PfISD 2024 Multi-Campus HVAC and Control System Renovations

Northwest ES, Windermere ES, Provan OC

Addendum #2 January 13, 2025

Item 7: New Roof Access Ladders at Northwest ES.

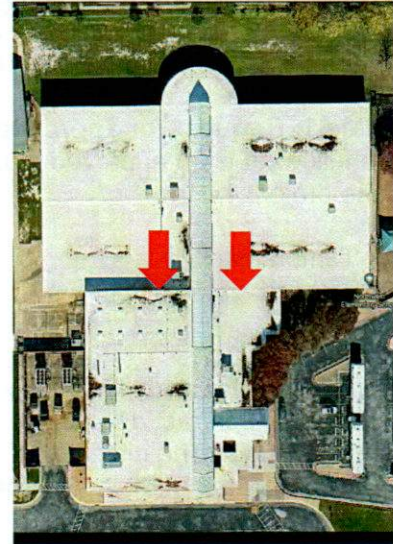
Contractor to provide and install two new metal roof access ladders at NWES to facilitate PflSD Maintenance access to adjacent roofs. Ladders to be Alaco Ladder Model 561 Handrails Over Roof or Engineer Approved Equal. Ladders to be located at approximately the arrowed locations to the right; verify final locations with PflSD Maintenance Staff.
